Access Compliance Report

Public Rights-of-Way

(Curb Ramps)

Intersection ID: 48158	Main Street: POINT_O'WOODS_DR	Cross Street: NORTHLAKE_CENTRE_PY	Location: NW
ADA ID: 32208B88794A	Ramp Type: Perp	Initial Pass/Fail: Pass	Overall Compliance: No
Codes/Mitigation Info/Possible Solution		Field Measurements/Component Compliance	
Severity Score: 5

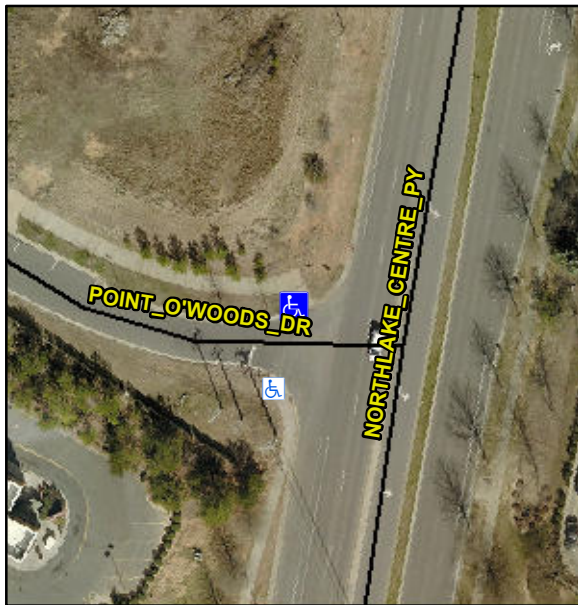
Possible Solutions:

**Remove & Replace Entire Ramp.
Remove & Replace Gutter.**

PROW/ADA:

R304.5.3, R305.2, R304.5.4
